**STAFF REPORT:** 07-08-2020 MEETING

**APPLICATION NUMBER:** 20-6673

**ADDRESS:** 308 ELIOT

**SCOPE:** REHABILITATE STRUCTURE, NEW WINDOWS, BUILD REAR 3-STORY DECK, INSTALL WOOD SIDING ON GARAGE, FRONT YARD LAMP POST

*Above: 308 Eliot*

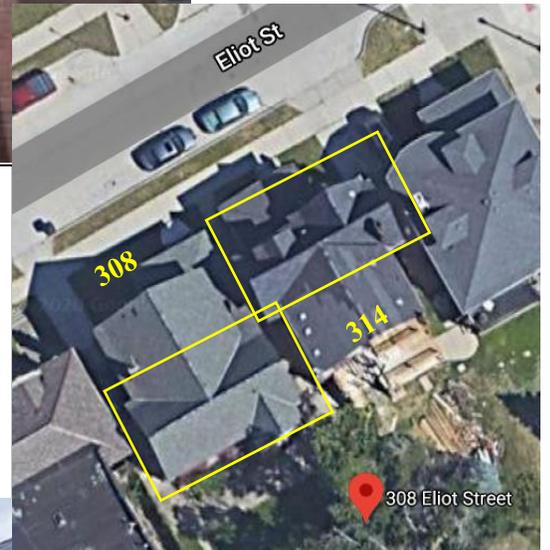
- The proposed gable redesign would change the historic architectural proportions of the house as well as its sympathetic, and slightly mirroring, relationship to the neighboring structure. Adding details to a house that were not there is in direct conflict with Standards 2, 3 and 6.
- Photographs of the side elevations were not submitted. If overall photographs can't be taken due to the close proximity of the adjacent houses, multiple pictures can be submitted.
- A catalog cut for the Velox window is needed to confirm its profile and how far it will protrude from the roof.

There are many similarities between the neighboring houses, with staff identifying both as examples of Tudor Revival/Craftsman (an emerging style at the beginning of the 20<sup>th</sup> century). Each house has a cross-gable; one is at the front (314), the other is at the rear (308). Carrying down from the cross gables are boxed out overhangs (314) or a double bay window (308). Side-by-side windows in gables that display half-timbering details, extended and elaborated rafter ends, exposed rafter tails, and deep porches with brick piers, create a cohesion between the two structures.

HDC staff recommends the Commission deny the issuance of a Certificate of Appropriateness for the gable design and color scheme, as proposed, as it would cause the removal of features and spaces that characterize the property and does not meet the Secretary of the Interior’s Standards for Rehabilitation, specifically Standards:
